Certificate of Appropriateness

2015 N. PALMER ST.

PTS ID 114358 COA: replace 2nd floor front windows

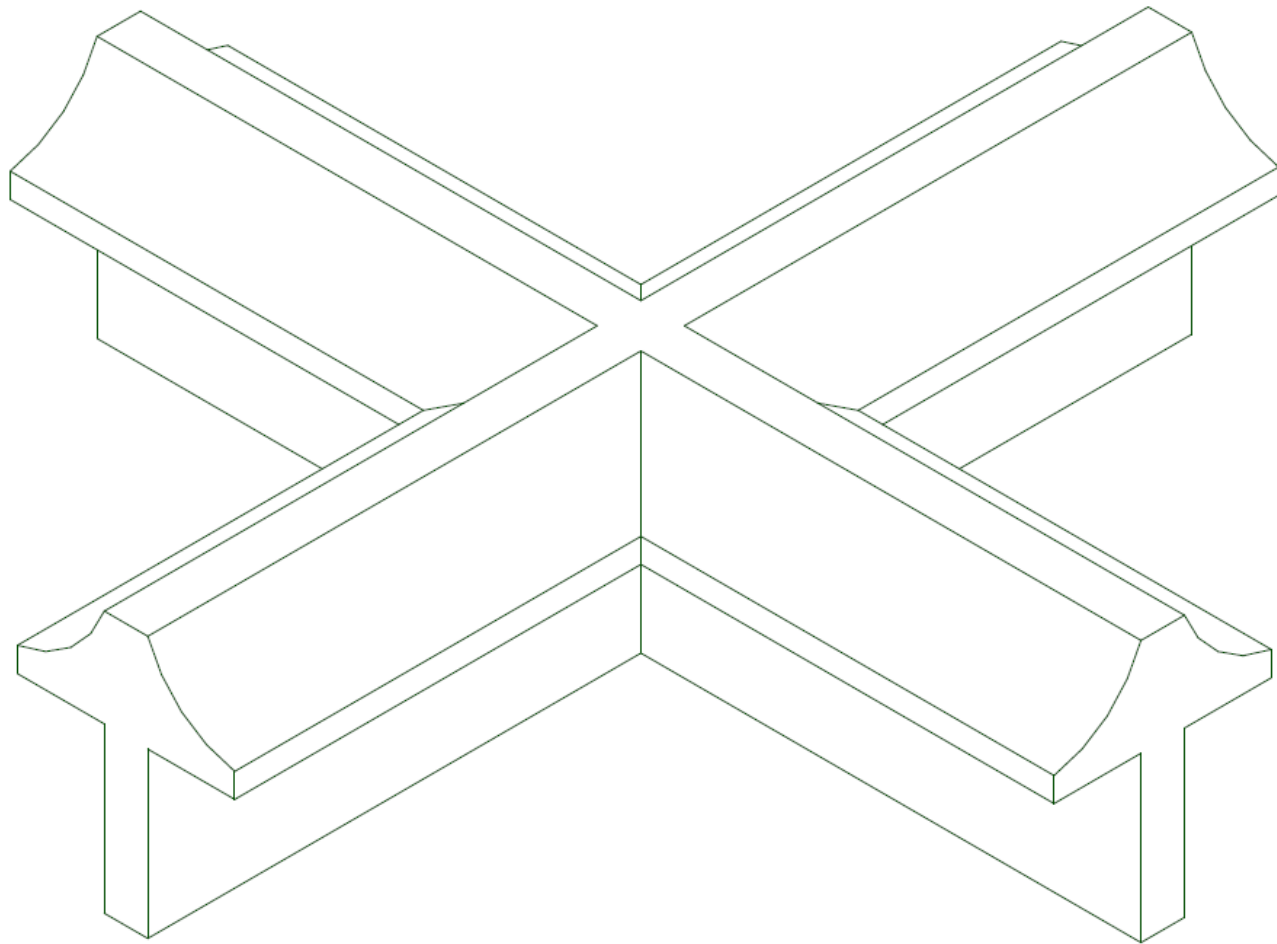
Exact design for front windows. Rear window shall be the same style with the same sash member thicknesses, but with dimensions adjusted as needed and arch-topped glass optional.
